CERTIFICATE OF APPROPRIATENESS

Property: 1040 Key Street, Lot 10, Block 133, North Norhill Subdivision. The property includes a historic 1,400 square foot, one-story wood frame single-family residence and detached garage situated on a 5,000 square foot (50' x 100') corner lot.

Proposal: Alteration – Make the following alterations:

Recommendation: Approval

NORTH ELEVATION – FRONT FACING KEY STREET

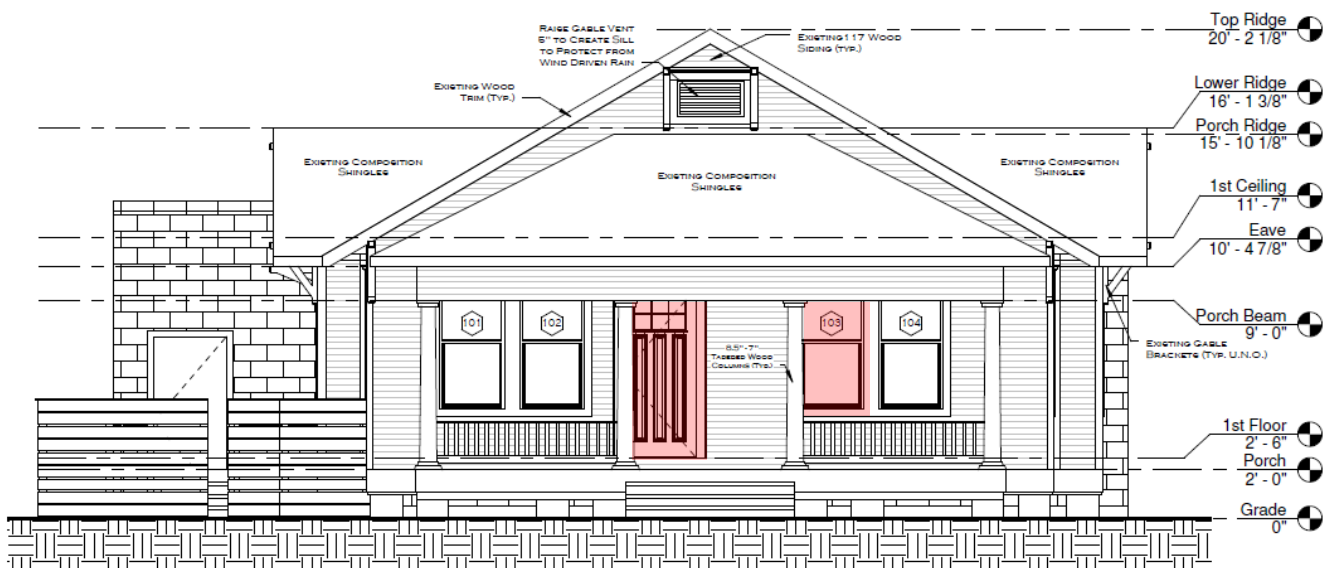
Front Elevation: The existing front elevation features full width front porch with four square columns supporting the
(North) hipped porch roof. A pair of windows is located on the eastern bay of the façade followed by a door offset to the west in the central bay and a single window on the eastern bay. A vent is located in the main gable.

The proposed front elevation will retain the full width porch. The existing columns will be replaced with four slightly tapered columns. The western pair of windows will be maintained. The existing door will be shifted to the west and the opening flipped (restoring the door to the original location and configuration). A salvaged window will be installed directly to the west of the existing window on the eastern bay (restoring the original paired appearance). The gable vent will be slightly raised. See drawings for more detail.

WEST SIDE ELEVATION

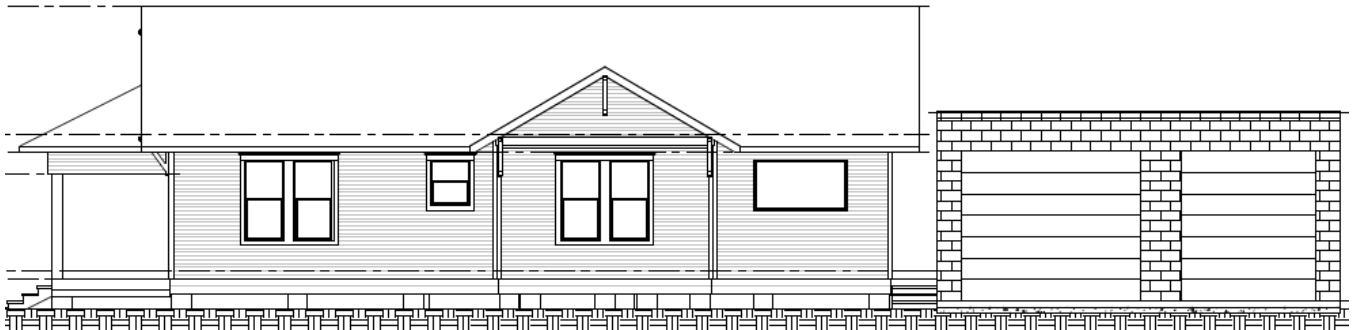
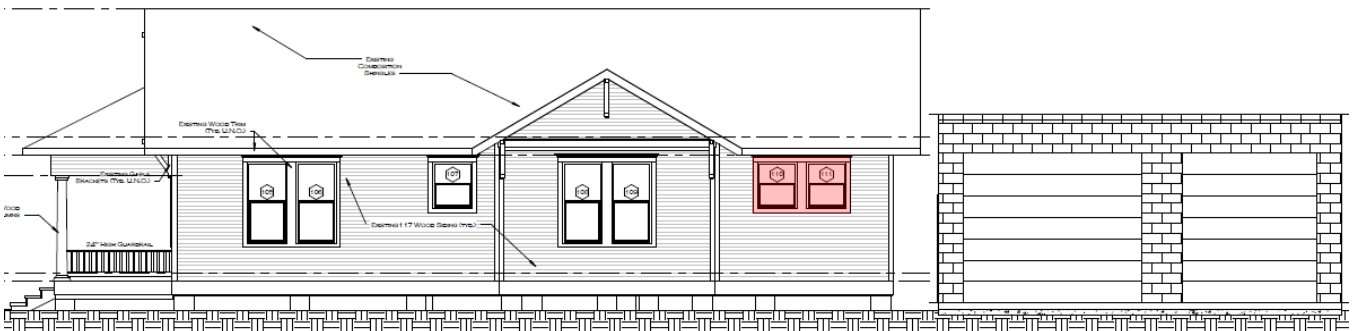
Side Elevation: The existing west elevation features the profile of the front porch at the north. A pair of windows
(West) will be located to the south followed by a single window. A gable topped pop-out features a pair of windows. The rear of west elevation features three non-original fixed windows.

The only alterations proposed for the west elevation will be the removal of the non-original windows and the installation a pair of salvaged windows to match existing. All other elements and material is to remain. See drawings for more detail.

EAST SIDE ELEVATION

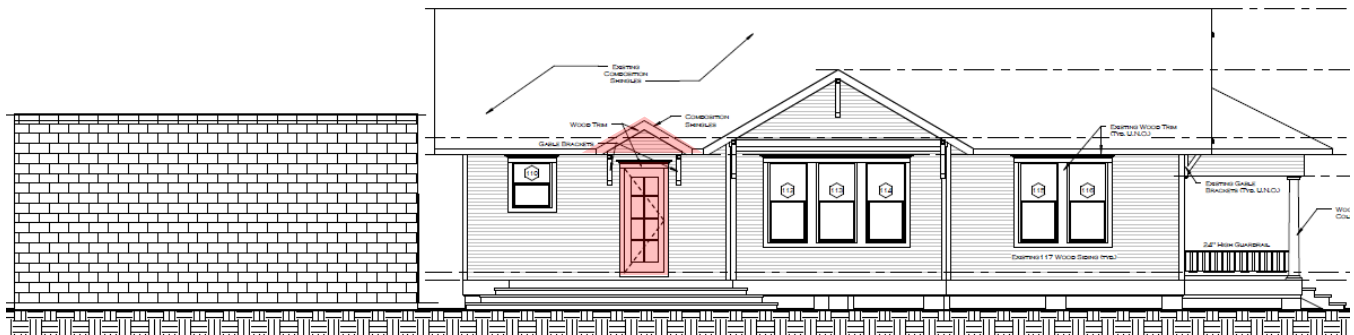
Side Elevation: The existing east elevation features the profile of the front porch at the north. A pair of windows
(East) will be located to the south. A gable topped pop-out features a group of three windows. The rear of west elevation features two additional windows.

The only alterations propose for the east elevation is the conversion of one of the rear windows into a door. The northernmost rear window will be removed and the existing opening extended to allow for the installation of a door. A small gable roof will be installed above the new door. All other elements and material is to remain. See drawings for more detail.
